**Notice of Additional Protective Function for AC Servo Driver A6N Series E-frame**

■ Affected Models: AC Servo Driver A6N Series E-frame 200V specification

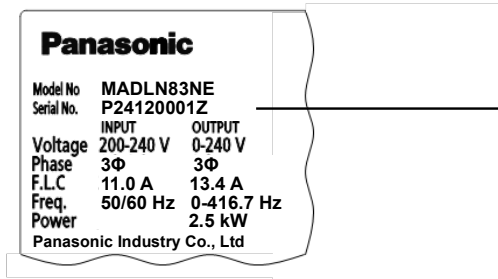
Change contents	Before change	After change
Added Protective Function	Err15.2 "Fan abnormal protection": Not supported	Err15.2 "Fan abnormal protection": Supported

A protective function has been added to protect the built-in regenerative resistor. If the cooling fan stops (malfunctions) for more than one second and the regenerative load ratio exceeds a specified value within the driver, the protective function will trigger the error code "15.2." When this protective function is activated, the driver will stop running the motor and output an alarm.
